Regional Review Finding

Development of Regional Impact

Name of Proposal: Hickman Property DRI 4422

Description: A regional DRI review of a proposal to construct a project with 6,220,000 SF of data center space in eleven buildings along with 66,000 SF of warehouse/distribution space in three buildings on a currently mostly wooded 736-acre site of which 700 acres falls within Douglas County and 36 acres falls within the City of Villa Rica generally located south of I-20 and east of Liberty Road.

**HICKMAN PROPERTY
VILLA RICA**

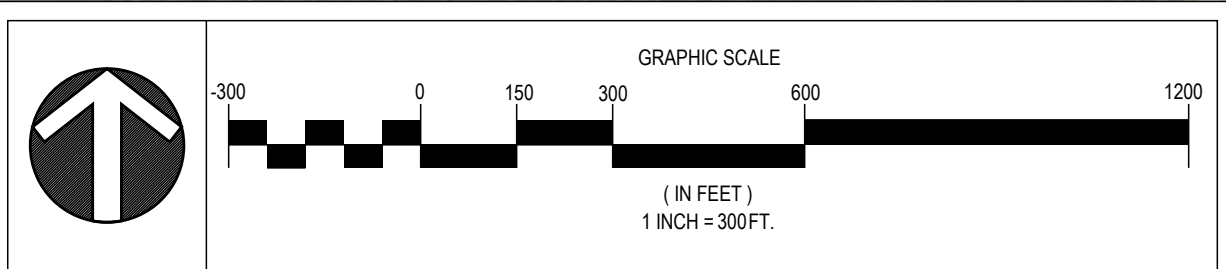
The USGS coverage for the project area and the submitted site plan both show an unnamed blue-line tributary of Keaton Creek, which in turn is a tributary to Dog River, running roughly northwest to southeast through the developed portion of the proposed project property along with two intermittent tributaries on the north side of the unnamed stream. The USGS coverage and the site plan also show Keaton Creek running from northeast to southwest across the eastern end of the developed portion of the proposed project and into the conservation area in the southeastern portion of the property. The site plan also shows several unmapped short tributaries and unconnected stream stubs across the proposed developed portion of the project property. The County 50-foot undisturbed buffer and 75-foot impervious setback as well as the State 25-foot Sediment and Erosion Control buffer are identified and shown on all the streams in the developed portion of the project. Other than existing utility easement crossings, the only intrusions into the buffers are two road crossings which are allowed under the County stream buffer requirements.

The FEMA coverage for the project area shows 100 -year floodplain areas along the unnamed tributary and Keaton Creek. The FEMA floodplain is shown on the proposed site plan, and the only intrusions are the two transportation crossings referenced under Stream Buffers.

Bike and pedestrian conditions are not accounted for. Though uses may not generate a substantial amount of bike and pedestrian movement, sidewalks and bike provisions should be considered for encouragement of alternative travel.

No. There is a substantial amount of parking on the site for the intended use. Consider converting some spaces to EV charging spaces.
